Department of Transportation

MEMORANDUM

SUBJECT: ZC Case No. 22-36 –Takoma Metrorail Station Redevelopment

Figure 1 | Site Plan

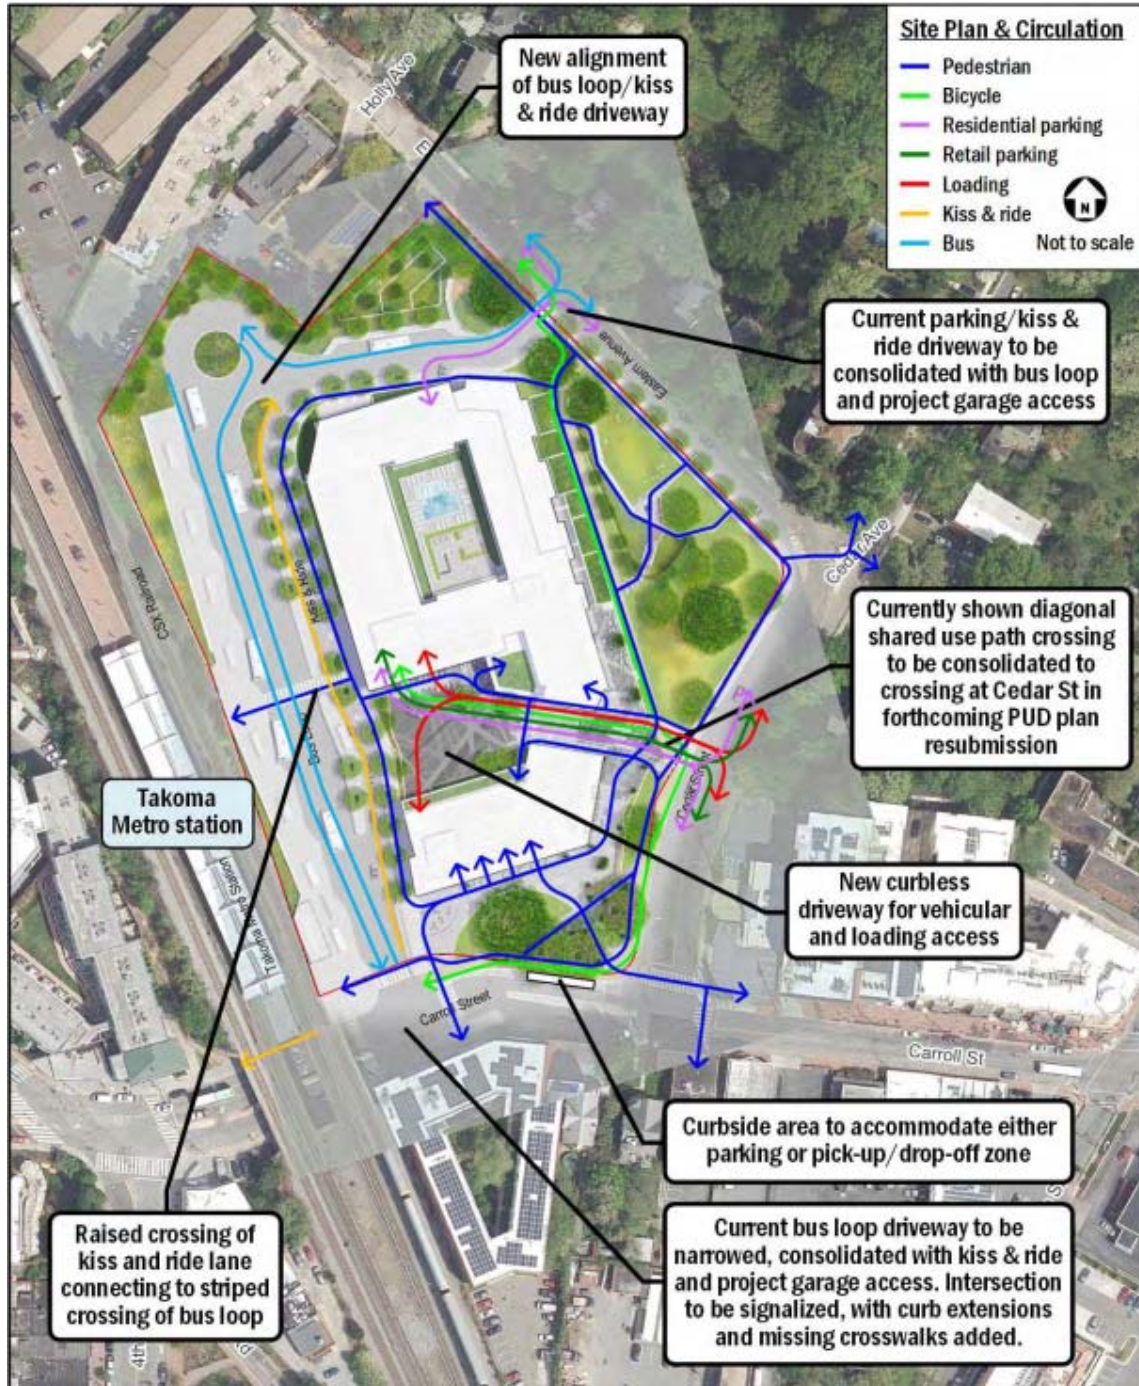
While the preliminary public space plans, shown above in Figure 1, are generally consistent with DDOT standards, there are several considerations that need to be reviewed in greater detail during the public space permitting process:

- The Applicant has proposed three (3) curb cuts onto the site, two (2) for the bus loop/kiss-and-ride and one (1) for all vehicular and loading access to the development. Ensure the curb cuts meet DDOT standards;

- A shared use path connection to the Metropolitan Branch Trail (MBT) is proposed within DDOT public space along Carroll Street. The materials of this segment should be coordinated with the DDOT Bike Planners and the design of the 12-foot portion to be located on private property;

- Provide a plan with proposed locations for short-term bicycle parking and all transportation network improvements in the TDM Plan, such as the intersection improvements at Cedar Street NW and Eastern Avenue NW. Short-term bike parking racks should be in public and accessible locations within the streetscape, not internal to the parking garage;

- Coordinate with CMD regarding the two (2) proposed kiss & ride spaces under the bridge. CMD’s initial feedback was that this space should not be used as signed kiss & ride spaces since there is sufficient space on private property for this function;

Figure 4 | Existing Pedestrian Network

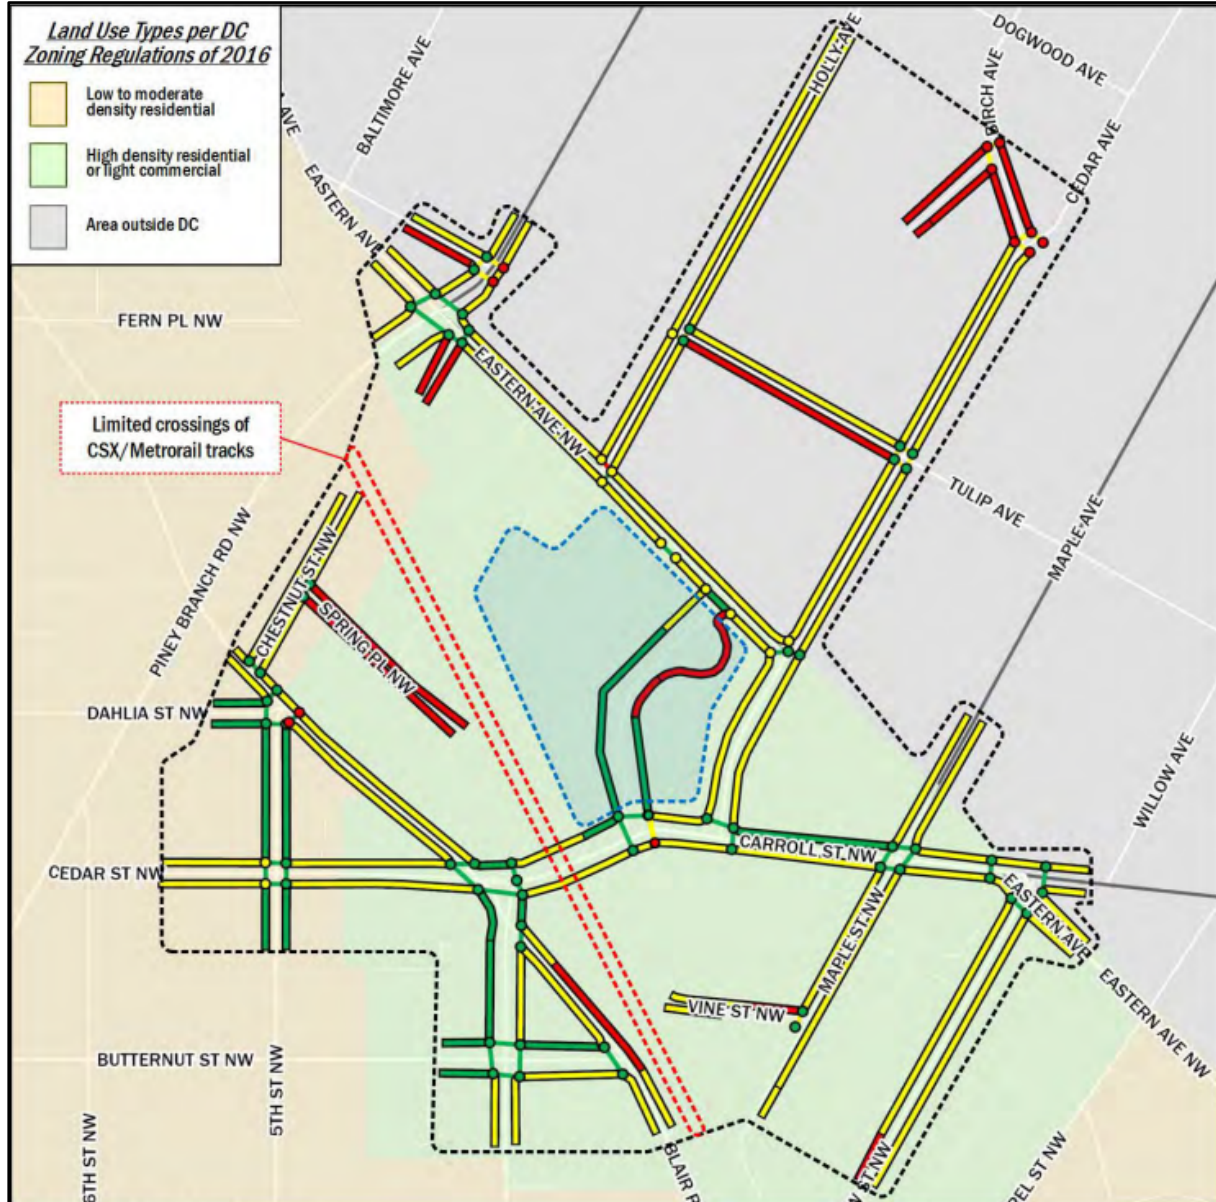
The CTR’s inventory of existing pedestrian infrastructure, as shown in Figure 4 below, demonstrates that most sidewalks in the immediate vicinity of the site are currently constructed with appropriate widths and include accessible curb ramps. While there are several missing or substandard facilities in the broader area, the existing pedestrian network along major walking routes from the site to schools, attractions, and the Metrorail station, are generally adequate and will be further improved around the site perimeter as part of this project.

- At the intersection of the proposed bus loop on Carrol Street:
 - Install concrete curb extensions on the northwest corner to replace existing flex-post and striped curb extensions;
 - Expand concrete median on Carroll Street to replace existing striping and flex-posts;

- Install concrete curb extensions on the south curb of the intersection to replace existing striping and flex-posts; and
- Install new crosswalk on the eastern leg of the intersection.
- Fund and construct pedestrian safety enhancements at the intersection of Eastern Avenue and Cedar Street NW, subject to DDOT approval. The construction will include a new concrete curb extension on the west side, removal of the concrete island, installation of any missing curb ramps, striping, and signage.
- Installation of a traffic signal at the intersection of Carroll Street and bus loop/kiss & ride entrance, subject to DDOT Traffic Engineering and Safety Division (TESD) approval. If approved by TESD, not only will this signal serve the needs of WMATA buses but will help provide safe crossings for pedestrians seeking to access the Metrorail Station.
